BULLETIN NO. 52

JEFFERSON LAB

TECHNICAL ENGINEERING & DEVELOPMENT FACILITY (TEDF Two)

Bulletin No.52
Project No. 20080400
June 09, 2011

PROJECT: TECHNICAL ENGINEERING & DEVELOPMENT FACILITY	PROJECT NO. 20080400	DWG. DATE 6/9/11
DRAWING TITLE: TLR EAST ELEVATION GIRT	REF. DWG. S2.1.7.B	REV. DATE
	SCALE AS NOTED	DRAWING NO. CP-S23
	DWN. BY BEC

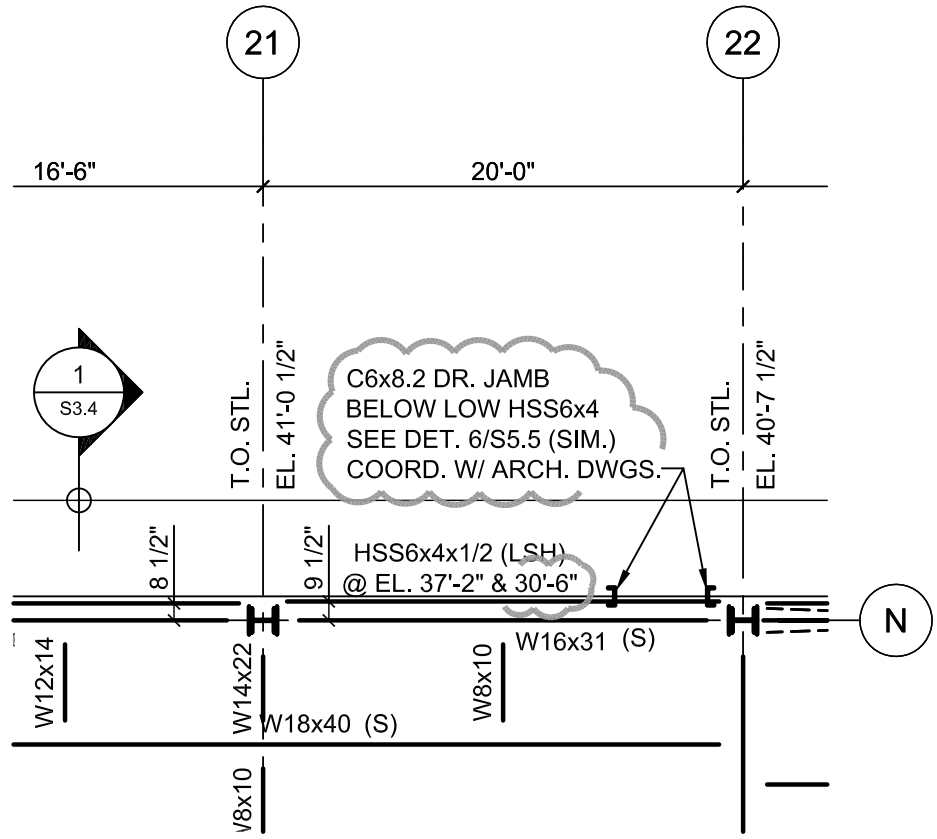
1. Girt added between column lines 21 and 22 along column line N at top of steel elevation 30'-6". Channel door jambs indicated in plan.
